Amendments to the Drawings:

REMARKS

Fig.3

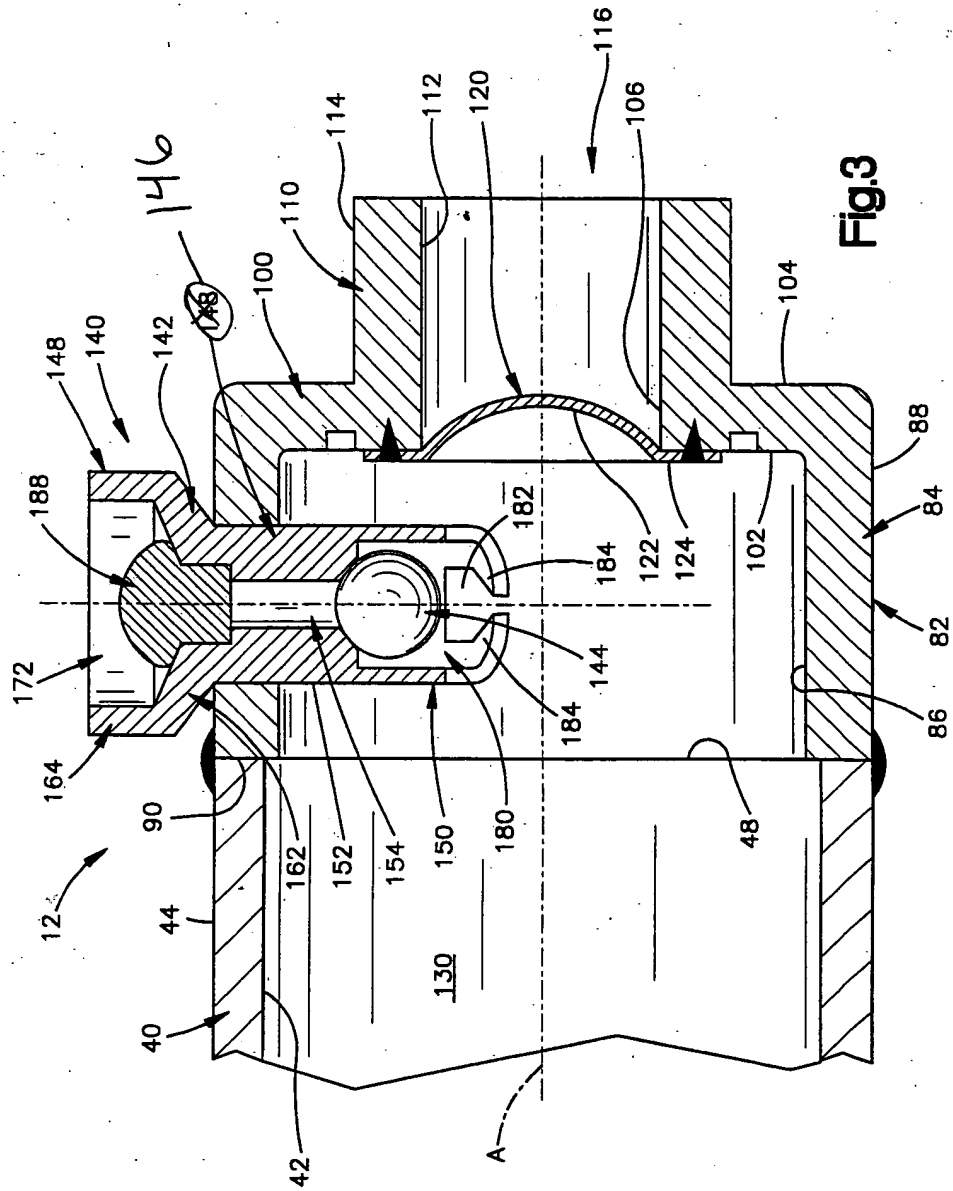
Attached is a copy of drawing Fig. 3 with a red ink marking showing proposed changes to the drawing in this application for which approval of the Examiner is requested.

Per the Examiner's suggestion, Fig. 3 has been amended to change the lower occurrence of reference number 148 to reference number 146.

A proposed drawing amendment is included with this amendment. The proposed drawing amendment proposes to change the lower occurrence of reference number 148 to reference number 146, per the Examiner's suggestion.
